Project DR2102 Drainage Improvements Orange Grove- Leisure Lane

Concerns – Questions needing clarification after public meeting dated May 19, 2021.

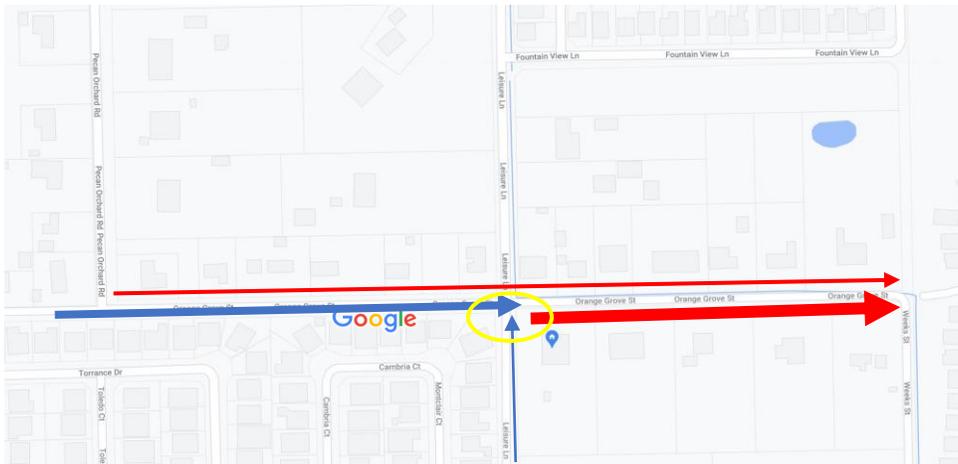
- 1) Existent Conditions Simulations Modeling at the corner of Orange Grove-Leisure Lane is inconsistent with the reality observed and lived through during major rain events.

Gauge Engineering simulations consistently show that the North Ditch, running alongside Orange Grove through Leisure Lane corner, has the biggest runoff amount of water. As a homeowner who has lived alongside these intersections for more than ten years, *this simulation is different than what we have observed and lived through during major rain events.*

The biggest amount of water runoff happens alongside the South side of the open ditch. This side running alongside the back of Victory Lakes (VL) flowing towards the corner of Orange Grove and Leisure Lane.

An engineering model should support what we have seen and experienced in every major event of heavy rain. Heavy runoff water does not turn 90 degrees simply because there is a North ditch in Orange Grove, but rather rushes across Orange Grove St and settles on the South open ditch against the back of Victory Lakes homes. All of the South ditch alongside Orange Grove runs towards the corner of Orange Grove and Leisure Lane.

Please provide data justifying this incongruity between modeling presented and actual lived and observed rain runoff performance.

The analysis simulation supports the reported drainage patterns. The graphical results that show inundation do not communicate the complete story of flow rates and volumes. The flow rates in the Orange Grove north ditch heading east to Leisure Lane are 6 cfs, 21 cfs, and 39 cfs for the 2-yr, 10-yr and 100-yr events respectively. The flows rates in the Orange Grove south ditch heading east to Leisure Lane are 18 cfs, 24 cfs, 33 cfs for the 2-yr, 10-yr and 100-yr events respectively. These flow rates tell us that, in the 2-year and 10-year events, the southern ditch has more flow, or close to the same flow, as the northern ditch. In the 100-Year storm event, the flow rates in the two ditches are similar to each other, because at this point both ditches are fully inundated and are being influenced by the water in Bensons Bayou. In the graphics presented at the public meeting, the inundation boundary for the northern ditch seems larger than for the southern ditch because the lots north of Orange Grove and west of Leisure Lane are lower than the lots south of Orange Grove, thereby allowing water to leave the ditch, expand into the yards and give the appearance it is -larger than the south.
